Project	<b>IEEE 802.16 Broadband Wireless Access Working Group</b> < <a href="http://ieee802.org/16">http://ieee802.org/16</a> >	
Title	<b>QoS Management <del>Subheader</del> for Facilitation of Uplink Scheduling</b>	
Date Submitted	<b>2004-07-07</b>	
Source(s)	Yongjoo Tcha, Yong-Bum Kim, Seong-Choon Lee KT 17 Woomyeon-dong, Seocho-gu, Seoul, 137-792, Korea	Voice : +82-2-526-6155 Fax : +82-2-526-5200 <a href="mailto:yjtcha@kt.co.kr">mailto: yjtcha@kt.co.kr</a>
	Jeong-Hwan Lee, Chung-Gu Kang Korea University 1.5-ka, Anam-dong, Sungbuk-ku, Seoul, , 136-701, Korea	Voice: +82-2-3290-3236 Fax: +82-2-3290-3691 <a href="mailto:ccgkang@korea.ac.kr">mailto: ccgkang@korea.ac.kr</a>
Re:	IEEE P802.16e/D3 Letter Ballot	
Abstract	This contribution introduces a new type of <del>MAC-subheader</del> QoS Management, which provides dynamic QoS parameters for uplink scheduling.	
Purpose	The document is contributed to support certain comment on IEEE P802.16e/D3 Letter Ballot.

# QoS Management **Subheader** for Facilitation of Uplink Scheduling

~~P 37. Figure 19—Generic MAC header format~~

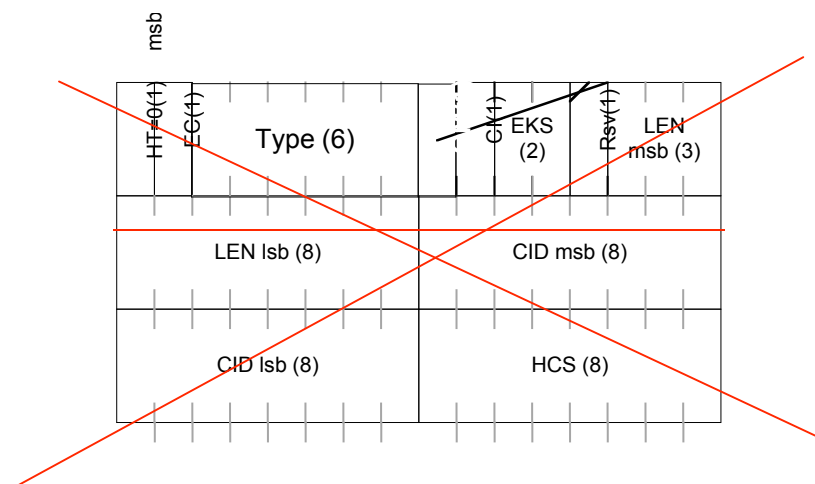
~~To support the uplink QoS parameters, a QoS management (QM) subheader is defined as an additional subheader. One reserved bit that is now a QoS management bit can be used to indicate the presence of the QM subheader. As the reserved bit is used, the existing format of MAC header is not subject to any change. If the QoS management bit is set, dynamic QoS Parameters shall be transported by a QoS management subheader. The format of the QoS Management subheader is specified in Table 14.~~

~~[Change the figure 19 in “the baseline document Section 6.3.2.1.1 Generic MAC header in page 37.”]~~

To support the uplink QoS parameters, a QoS Feedback IE is defined as an additional H-ARQ MAP message. And, a QoS management (QM) message is defined as a new message. Therefore, QM messages will be transmitted on the CQI Channel region.
